Dear Mr. Wu:
Subject: SLIC Case RO0002517, 7th St. and Mandela Parkway, Oakland, CA 94607

To: Jesse Wu
Subject: RE: Mandela Gateway (Oakland, CA)

Comments on Soil Management Plan for Mandela Gateway Project

MANDELA GATEWAY Oakland, California		
SOIL REMOVAL, EAST BLOCK		
Date 04/15/03	Project No. 3433.04	Figure 2
Treadwell&Rollo

MANDELA GATEWAY Oakland, California		
SOIL REMOVAL, WEST BLOCK		
Date 04/15/03	Project No. 3433.04	Figure 1
Treadwell & Rollo

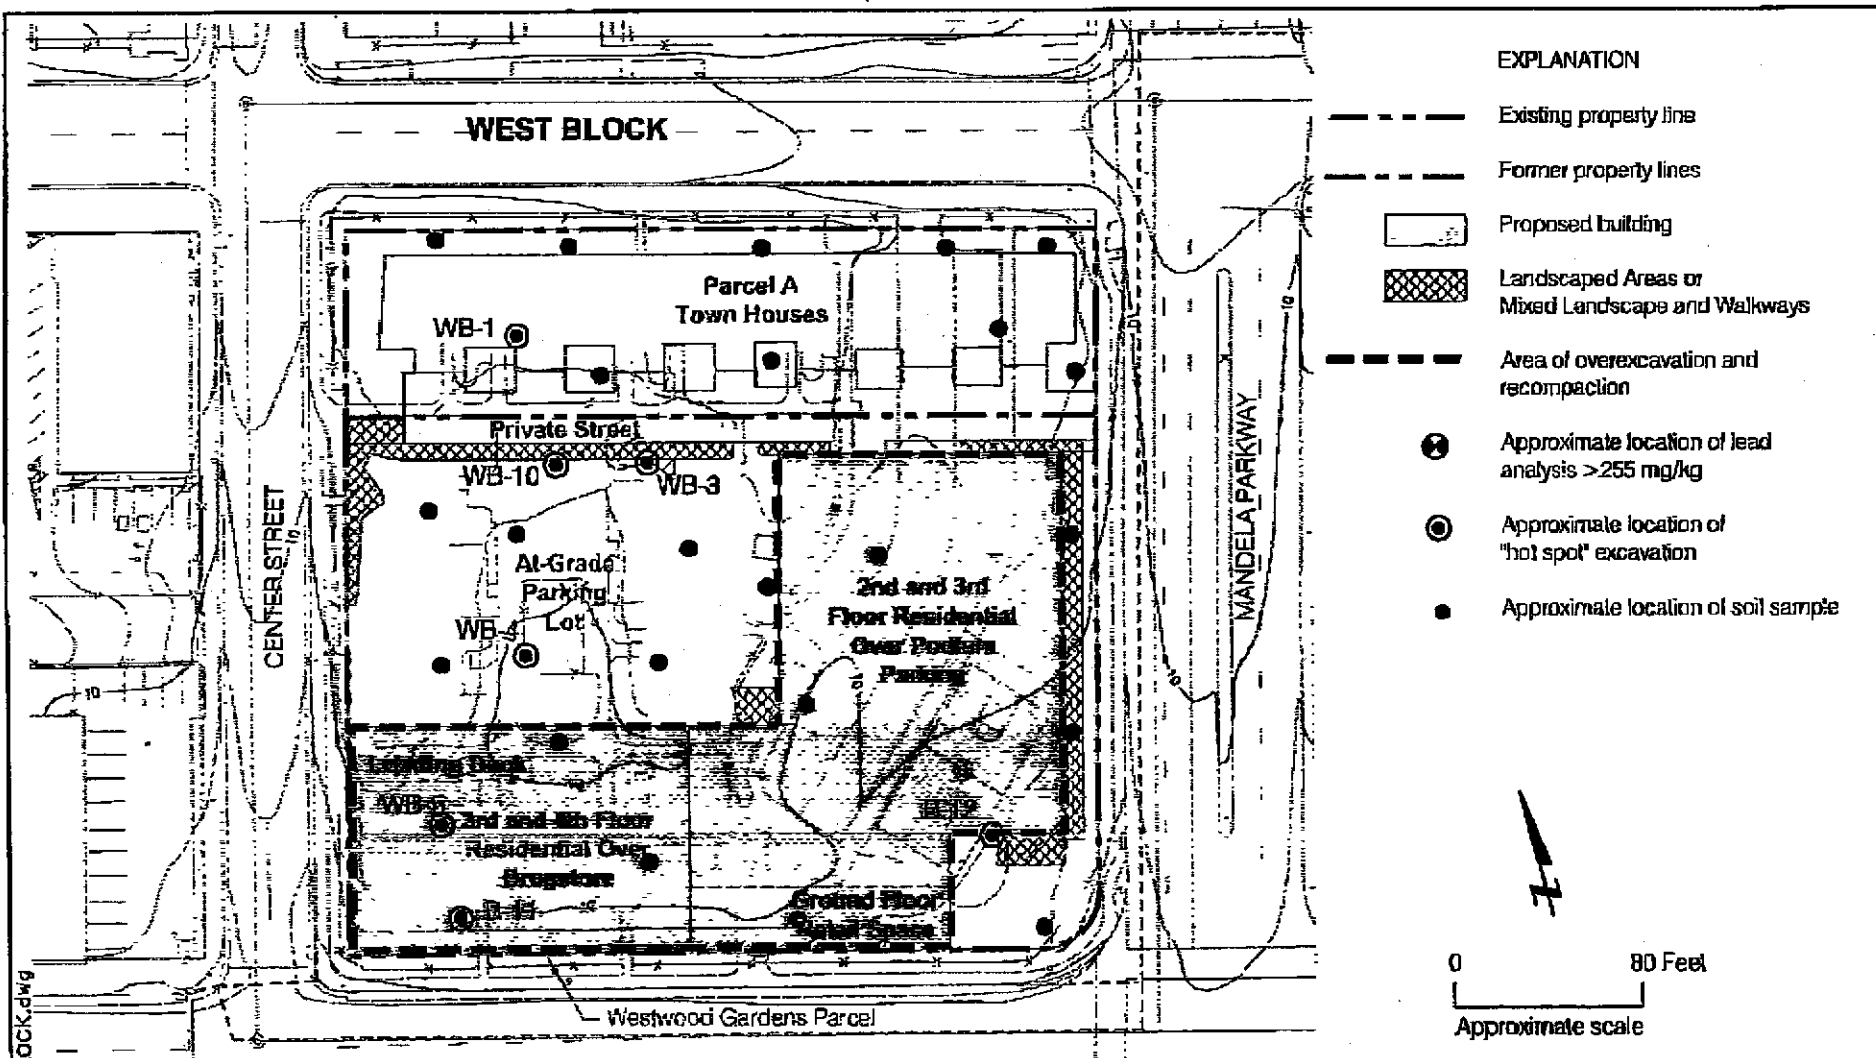
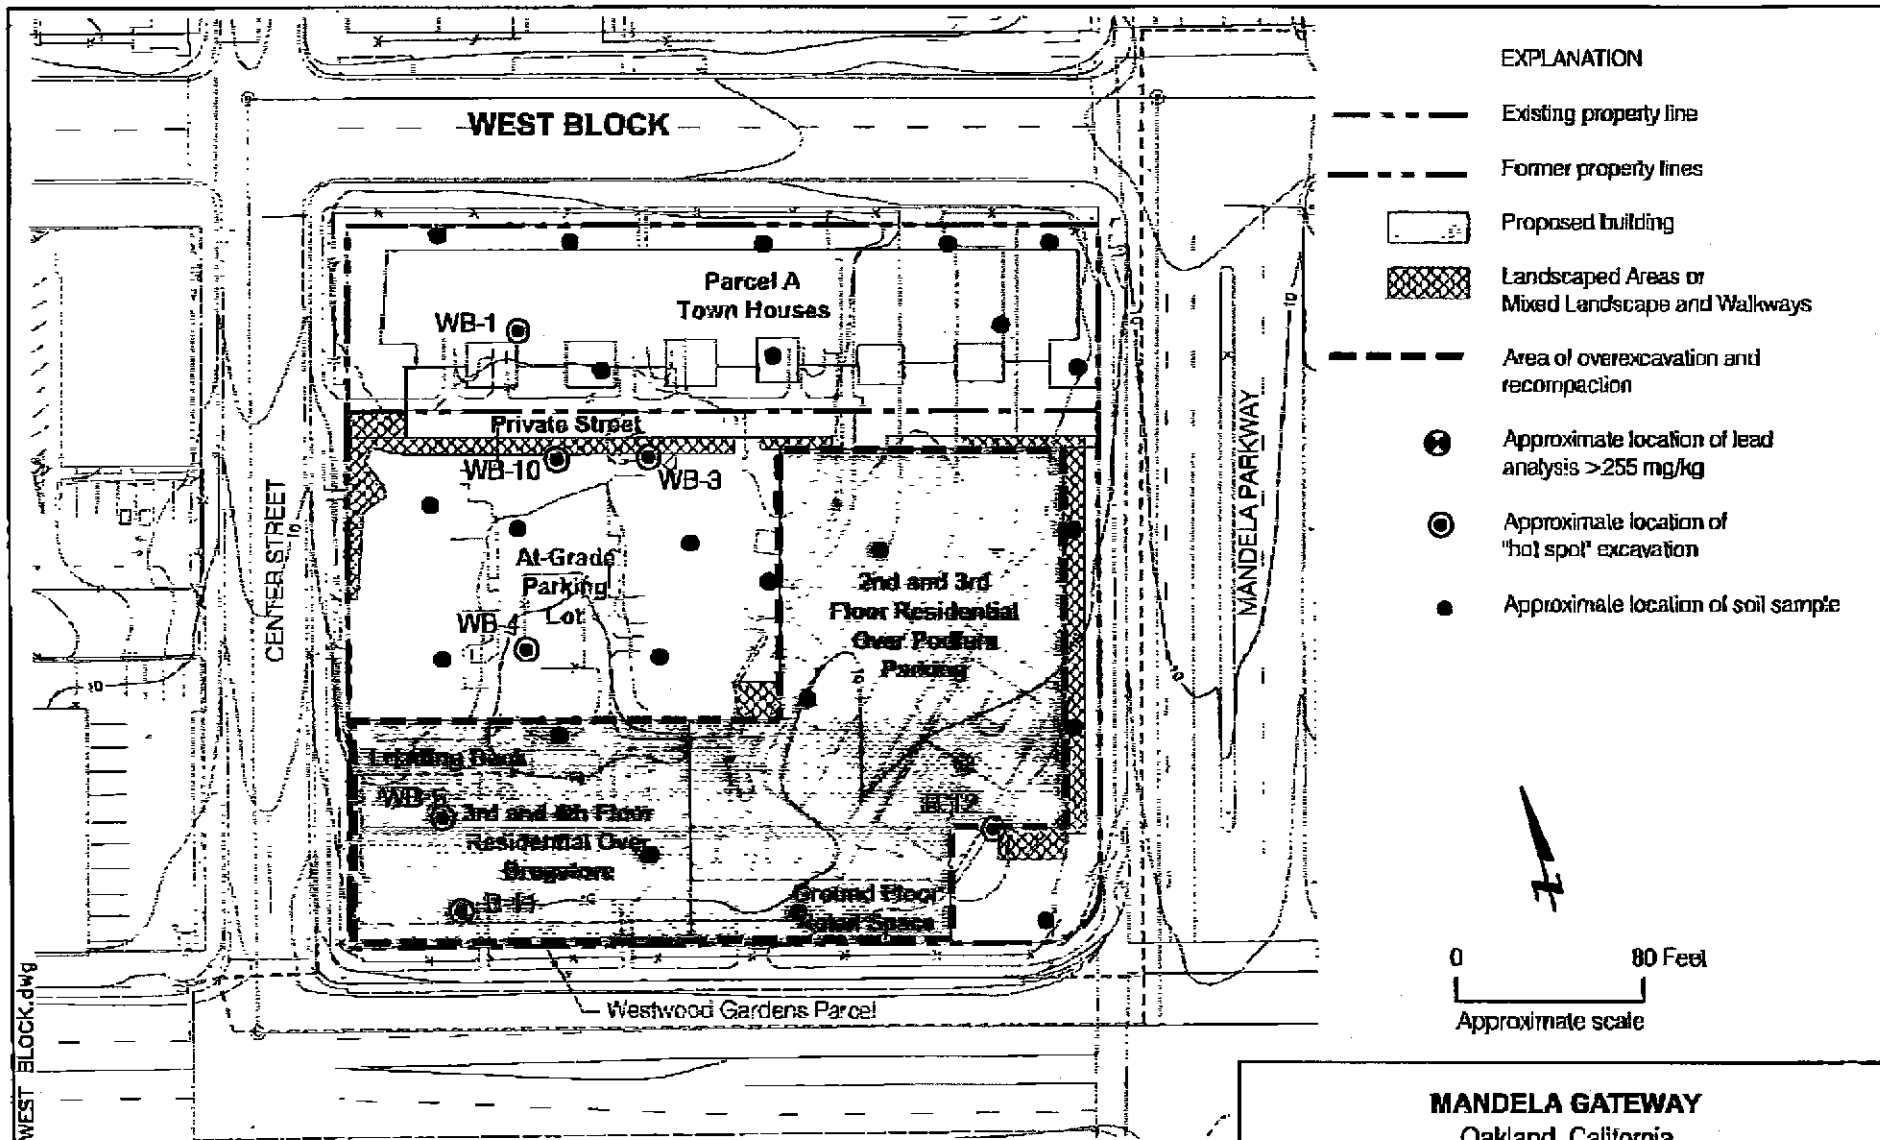
The attached Figures 1 and 2 show the locations of "hot spots" that have been excavated, or are currently being excavated, on the West Block and East Block, respectively. In the West Block, five excavations have been completed and two are currently being performed (WB-1 and WB-4). In the East Block, four excavations have been completed and two are currently being performed (EB-1 and B-3). The results of confirmation samples for these excavations are provided on the attached table.

MANDELA GATEWAY Oakland, California		
SOIL REMOVAL, EAST BLOCK		
Date 04/15/03	Project No. 3433.04	Figure 2
Treadwell & Rollo

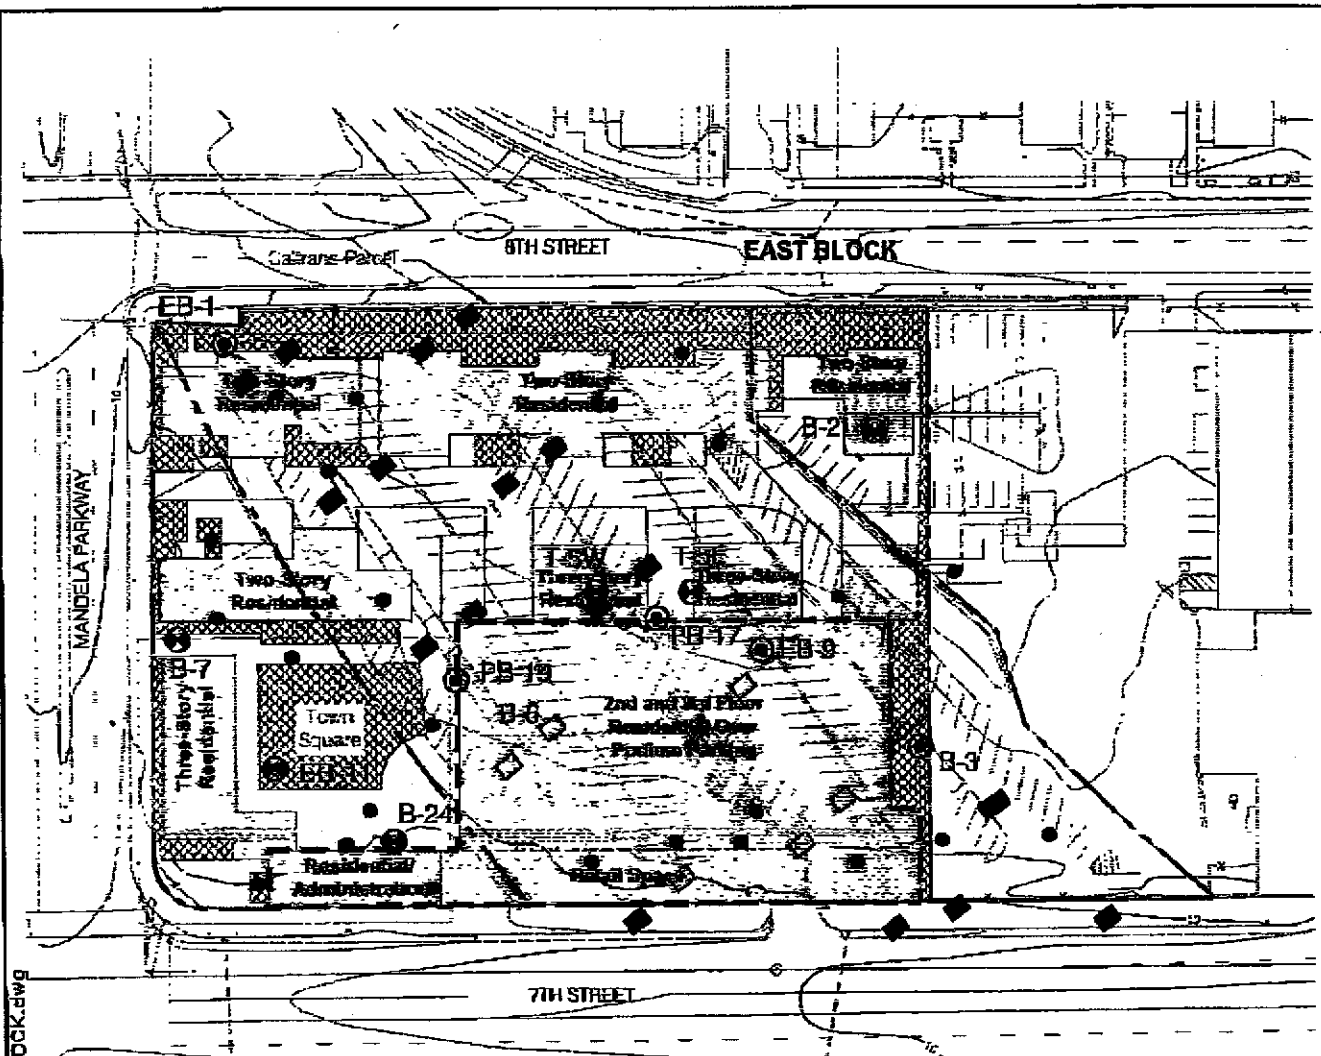
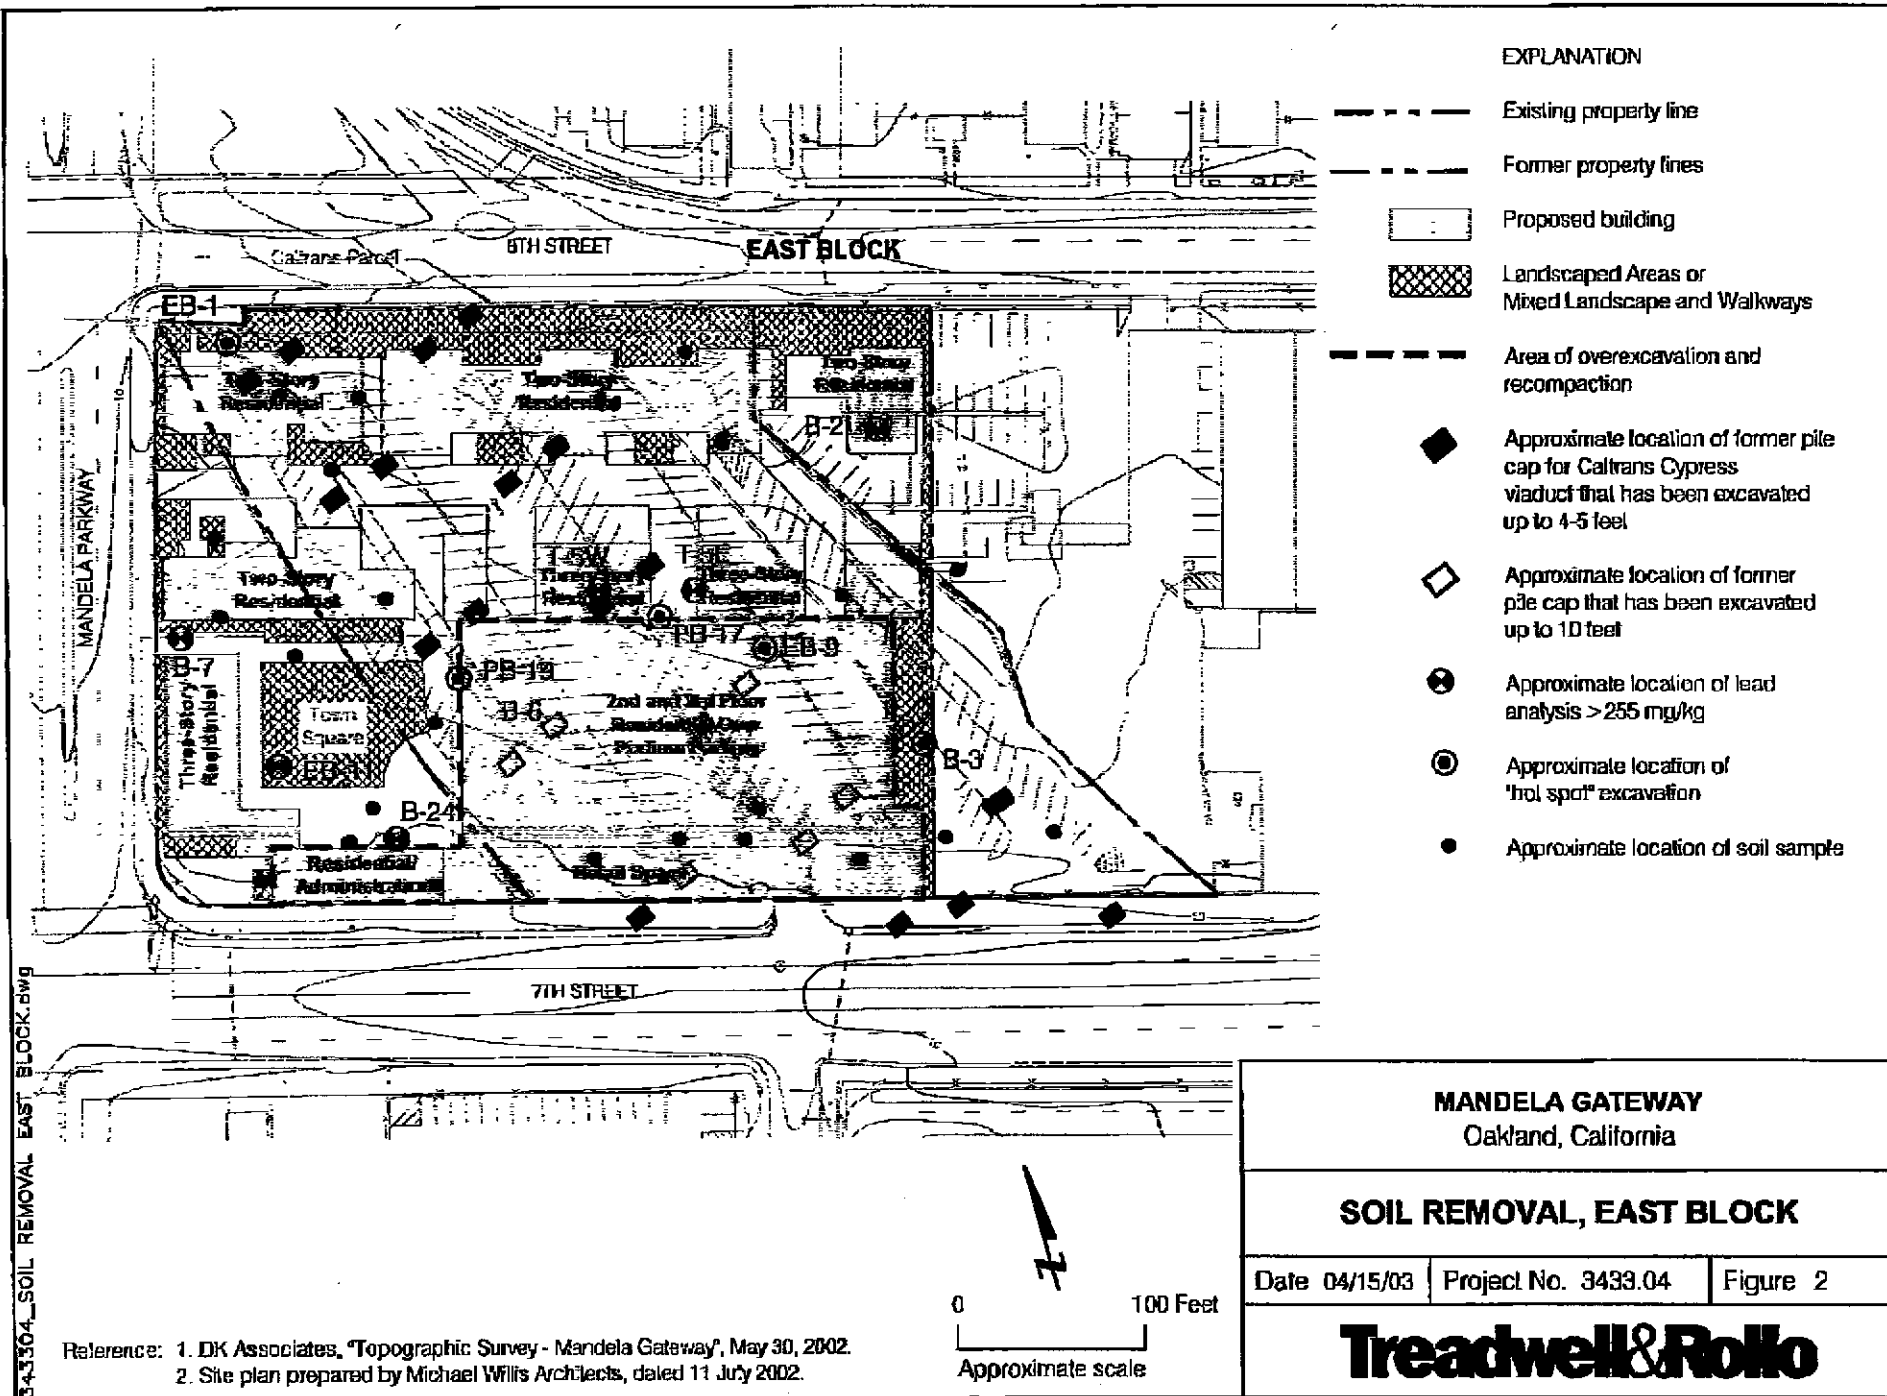
In addition, Figure 2 shows the location of excavations that have been completed to remove pile caps from the former Cypress Structure freeway in the East Block. These excavations removed soil from over and around the pile caps up to four or five feet below ground surface ("bgs") in northern parts of the site and up to eight to ten feet bgs in the Podium Area. Approximately 1,400 cubic yards (cy) of soil have been removed from these excavations. Of this, approximately 700 cy have already been sent off site as hazardous waste. Of the remaining 700 cy of excavated soil currently stockpiled on site, about half will be sent off site as hazardous waste, while the remainder has tested below the remedial target levels and will be reused in the podium area.

Remaining areas where lead or TPH-mo exceed remedial target levels, but will be capped in place, include the areas shown in Figure 2 around the borings B-7, B-24, T-5W, T-5E, and B-2. In addition, areas that will be capped with buildings or pavement where soil may be found to contain lead greater than the remedial target level include the roadway and buildings in the northern part of the East Block, the Podium Area, and building and paved areas in the J&A Trucking Parcel. We estimate the potential soil volumes with lead exceeding the remedial target level in these areas may be as much as 6,400 cy, resulting in a total cost (including costs already committed) for disposal of hazardous waste of approximately \$1.2 million. We understand from our client that, in light of the substantial removal costs already committed to the project, removal of all soil exceeding remedial target levels is cost prohibitive and could jeopardize this project's financial feasibility.

Need better
figure
